Subject: Issuance of Amendment No. 16 to Facility Operating License No. NPF-10, San Onofre Nuclear Generating Station, Unit 2

This amendment is in response to your letters dated September 3, October 21, and December 1, 1982 and February 4, 1983. The amendment updates the Unit 2 Technical Specifications to make them consistent with the San Onofre Unit 3 Technical Specifications.

SAN ONOFRE NUCLEAR GENERATING STATION , UNIT 2 (AMENDMENT NO. 16)

Figure 3.4-2

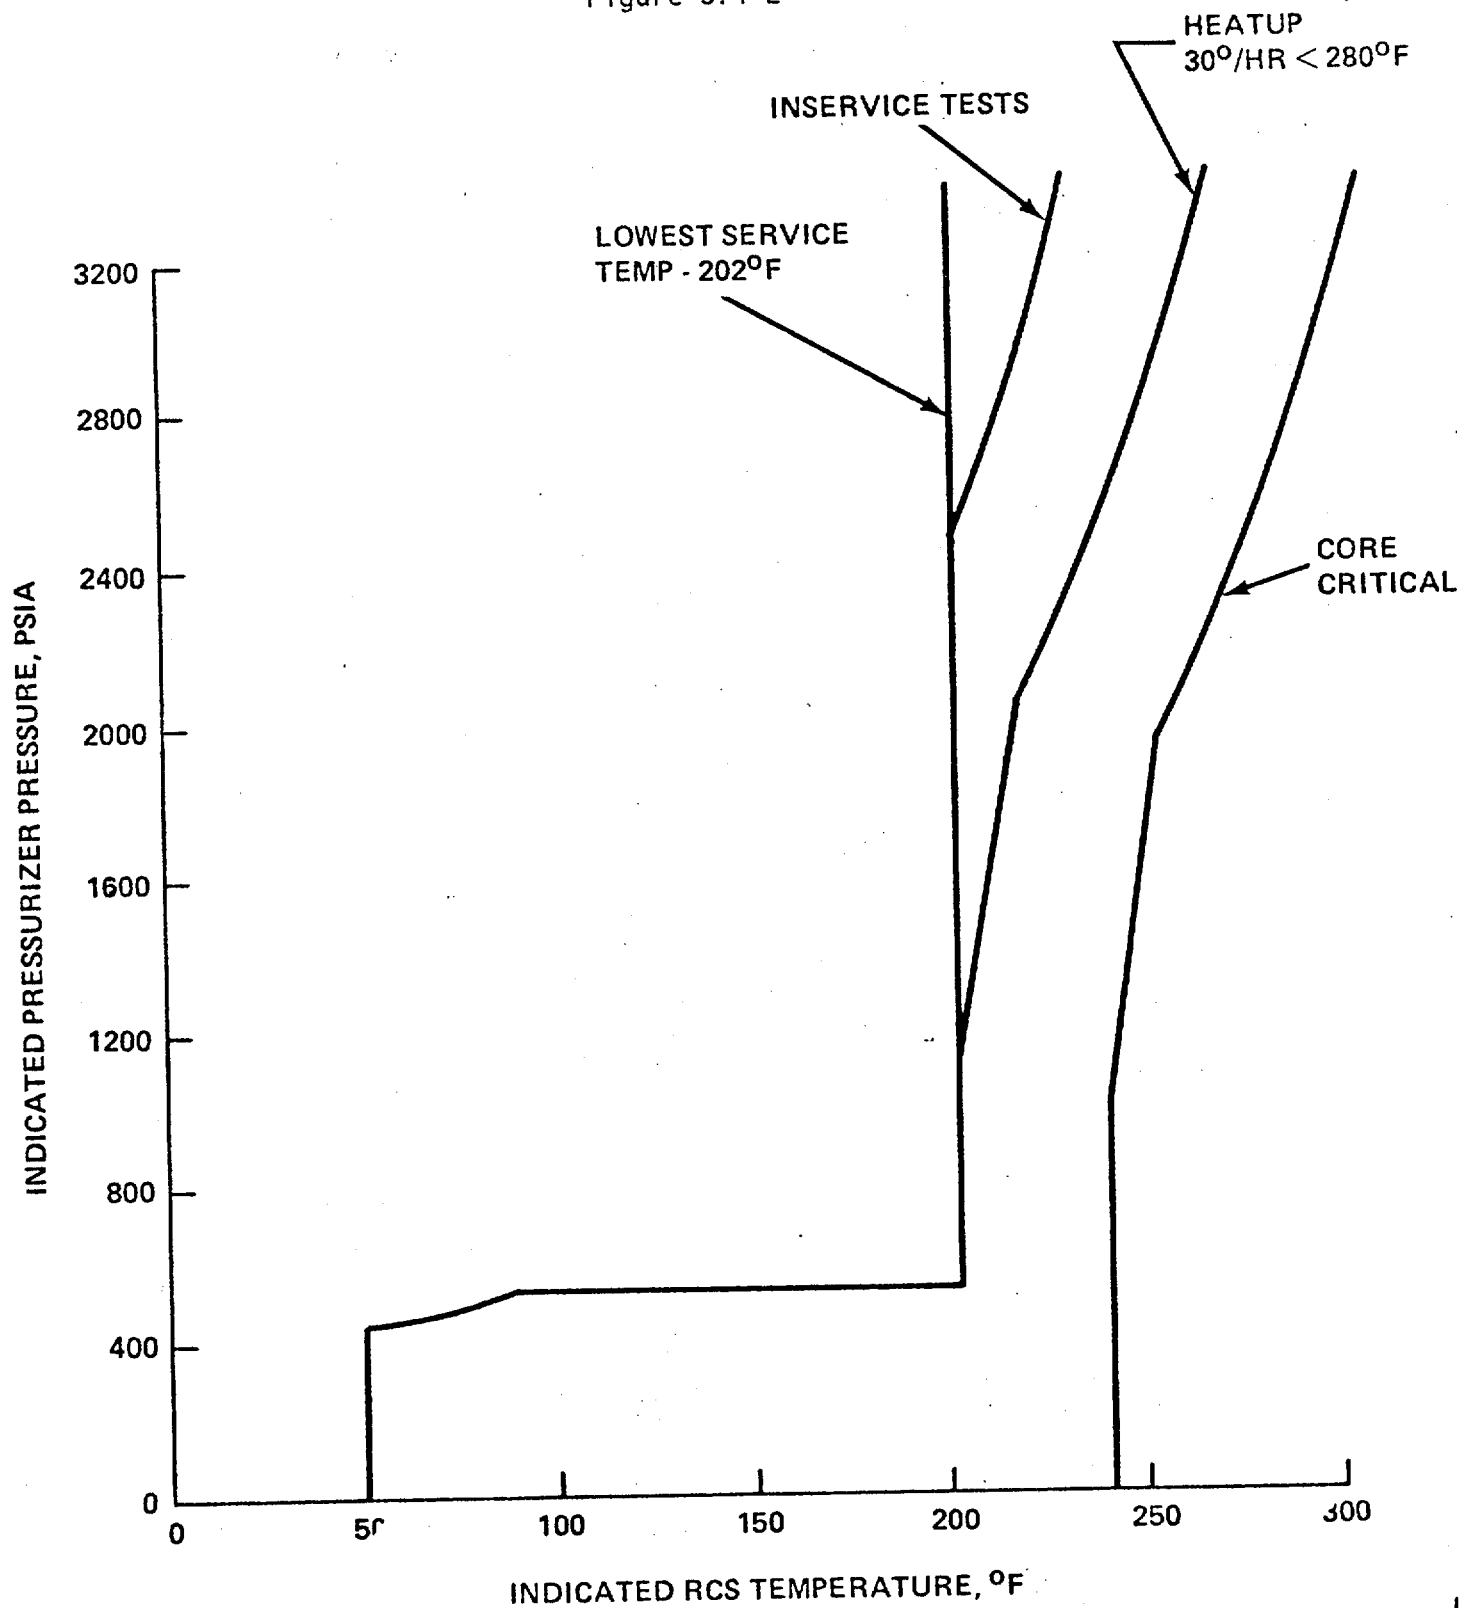
3.4.8.1 The Reactor Coolant System (except the pressurizer) temperature and pressure shall be limited in accordance with the limit lines shown on Figure 3.4-2 and Figure 3.4-3 during heatup, cooldown, criticality, and inservice leak and hydrostatic testing with:

Figure 6.2-1  
OFFSITE ORGANIZATION  
SAN ONOFRE NUCLEAR GENERATING STATION - UNIT 2

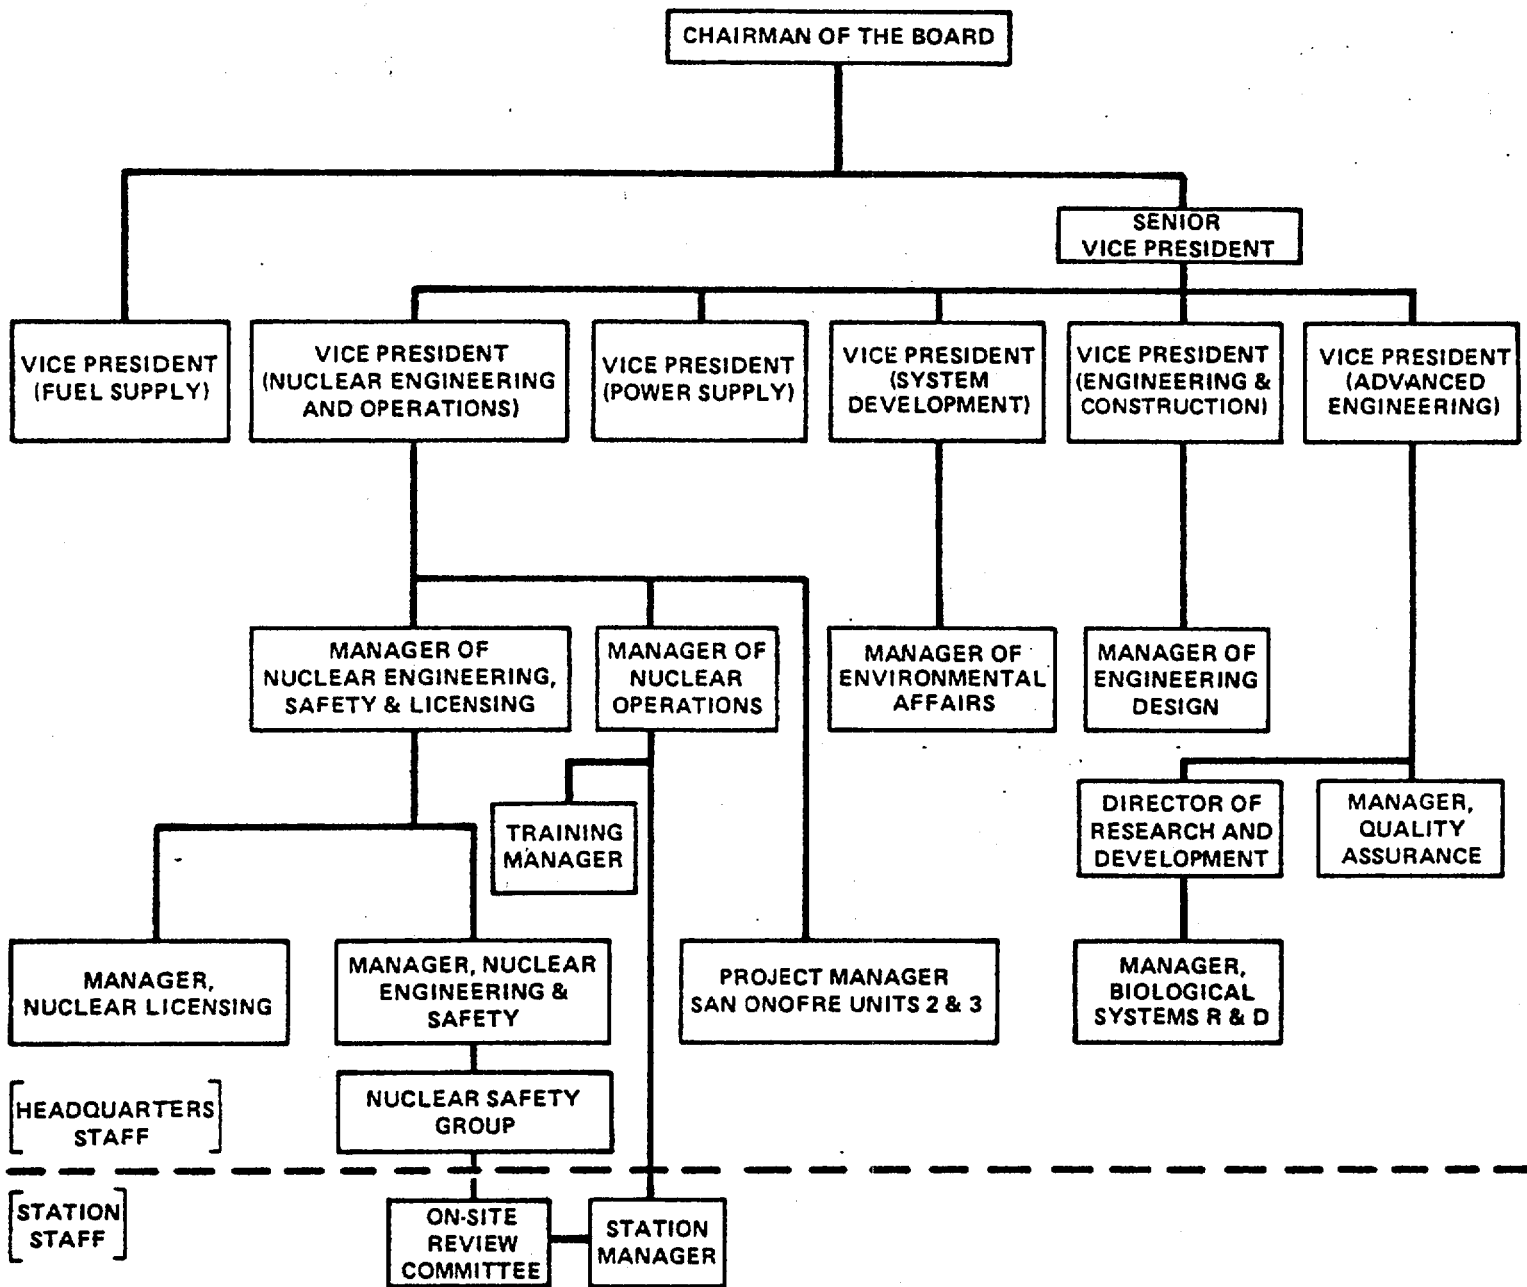
6.2.1 The offsite organization for unit management and technical support shall be as shown in Figure 6.2-1.

Figure 6.2-2 Unit Organization, San Onofre Nuclear Generating Station-Unit 2

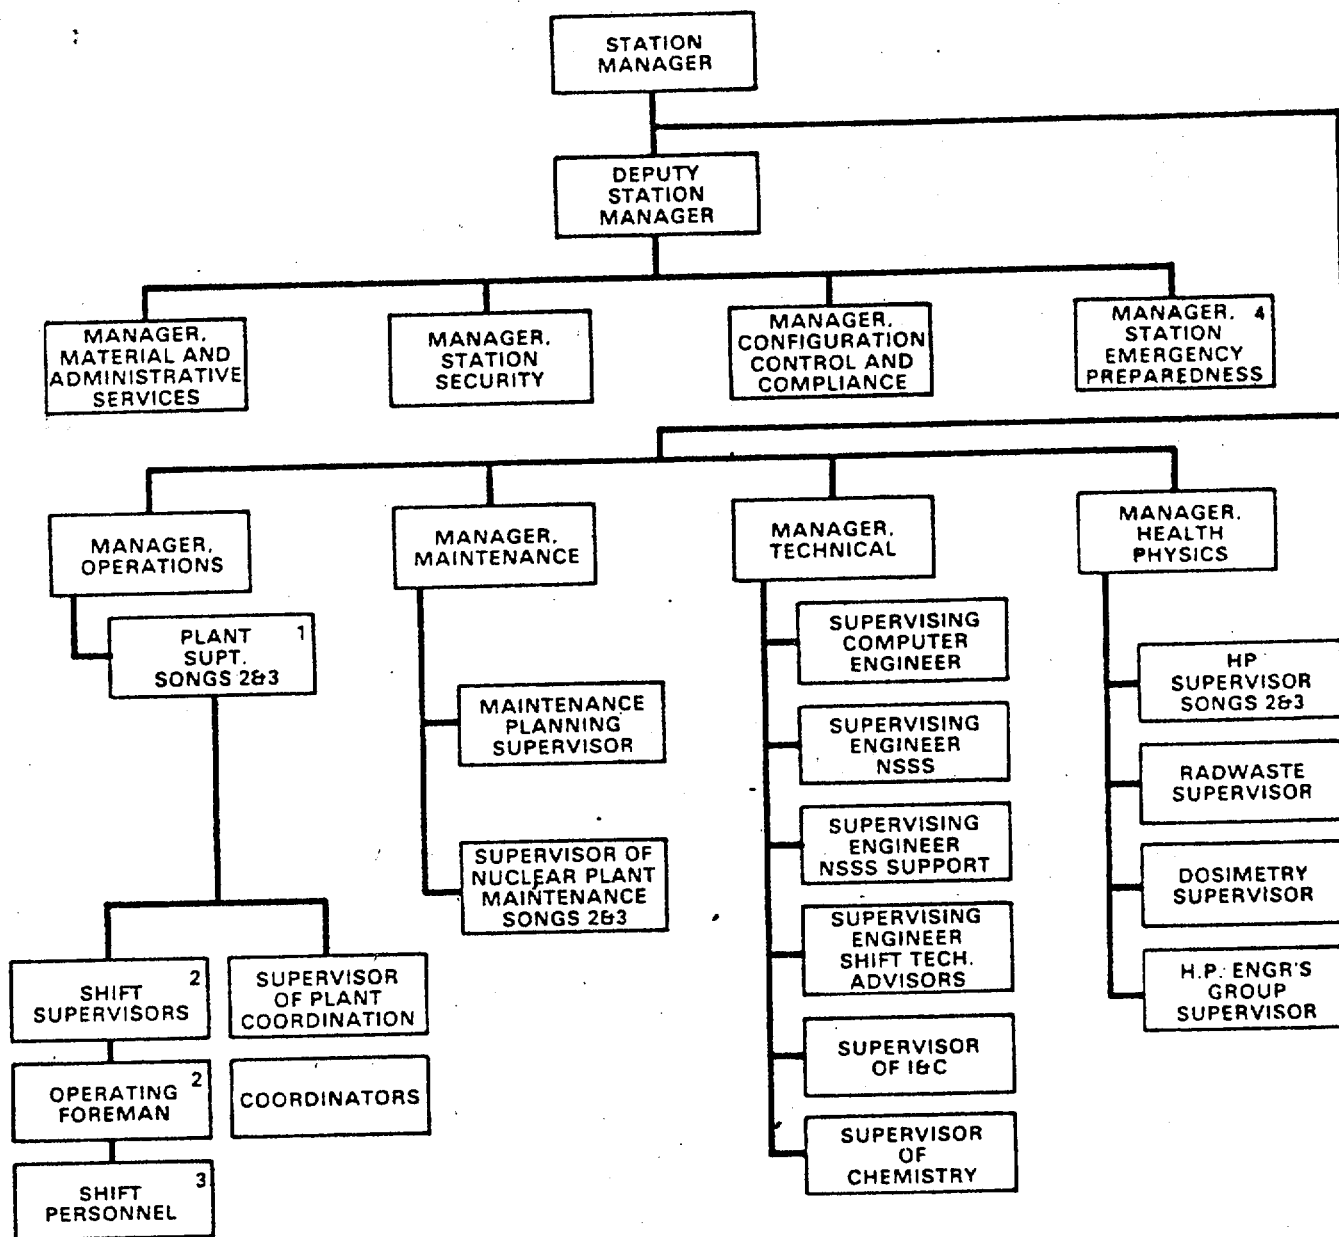
6.2.2 The Unit organization shall be as shown in Figure 6.2-2 and:
